## Mandatory Action Jan. 2017

Inspection of the Horizontal Stabilizer tail attachment brackets

Transportation Safety Board of Canada - **AVIATION SAFETY ADVISORY A16O0137-D1-A1  
Zenair Zodiac CH-601A—Risk of structural failure of the horizontal stabilizer**

**Subject: AVIATION SAFETY ADVISORY A16O0137-D1-A1**  
**Zenair Zodiac CH-601A – Risk of structural failure of the horizontal stabilizer**

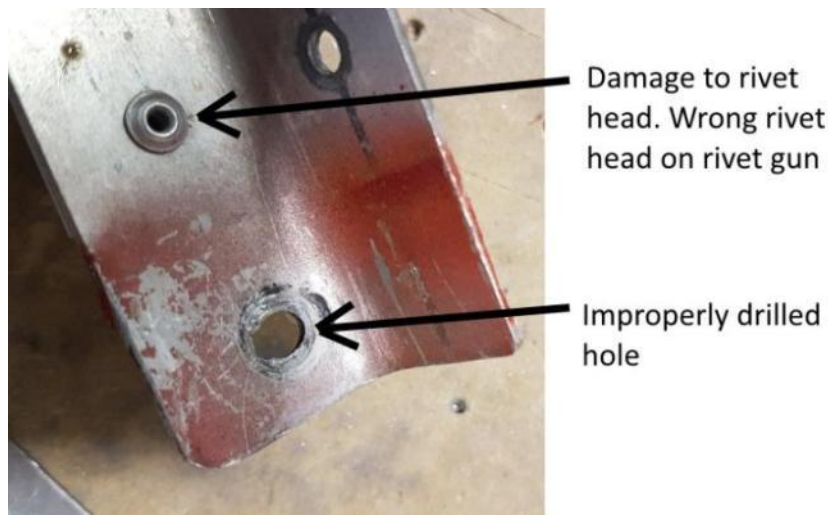
Crack

View of H.S. rear attachment bracket. A crack is developing in the part. Part must be replaced.

Above parts must be replaced.

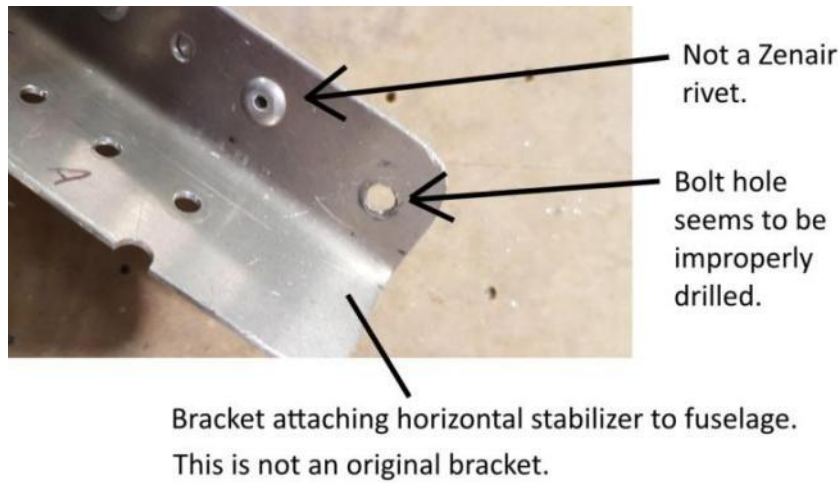
Strange hole.  
Part must be changed.

View of H.S. front attachment bracket. Bolt hole was not properly drilled. Part must be replaced.

**Figure 1.** Horizontal stabilizer forward structural attachment—aircraft drawing. (source: Zenair, with digital annotations by the TSB)

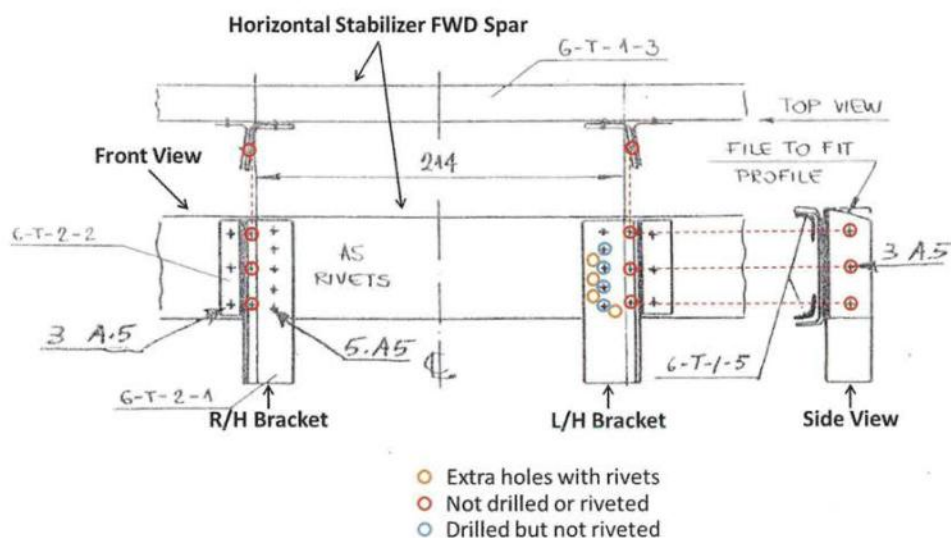
As per the drawing (Figure 1), the horizontal stabilizer forward structural attachment is designed to be constructed by riveting two aluminium angles (attachment bracket 6-T-2-1 and attachment doubler 6-T-2-2) with three rivets back-to-back and connecting the attachment bracket to the front surface of the forward spar (6-T-1-3) with five rivets.

In the actual installation, the three rivets connecting each attachment bracket to the associated attachment doubler were missing and the required holes were not drilled. Four additional holes were drilled through the left attachment bracket and continued through the forward spar. Rivets were installed in all of these additional holes; however, they were only installed in one of the five holes specified in the drawing.

Structural integrity of the horizontal stabilizer forward attachment point was compromised on both sides because of the missing rivets, and the strength of the forward spar itself was reduced because of the extra holes.
